Service Bulletin

Bulletin No.: P11004A

Subject: Malfunction Indicator Lamp (MIL) On, Service StabiliTrak, Power Steering or Vehicle Soon Message Displayed on DIC

Models: 2012-2014 Chevrolet Equinox
2012-2014 GMC Terrain
Equipped with 2.4L Engine (RPO LEA)
and Built Prior to October 1, 2013

3341023

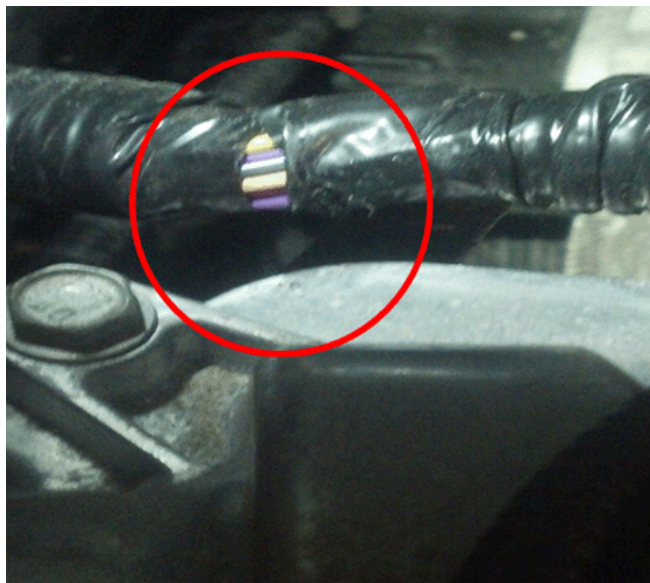
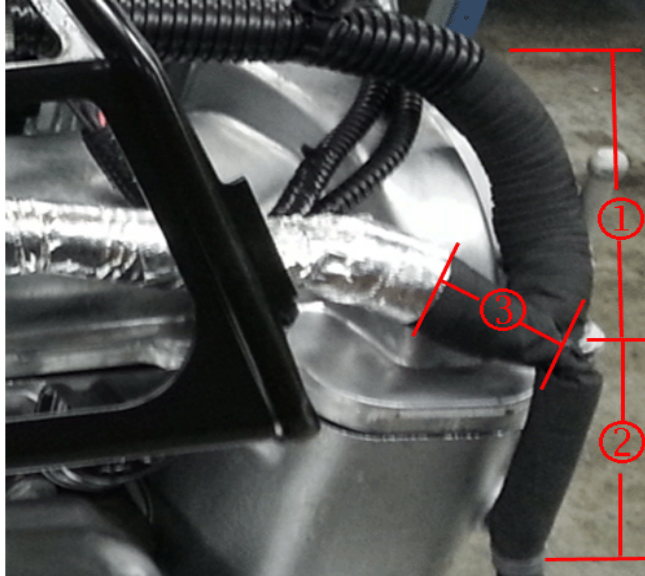
These conditions may be caused by one of the wires (in particular circuits 2500 and 2501) in the engine wiring harness being chafed, cut or damaged due to contact with the right rear corner of the engine or cam/valve cover.
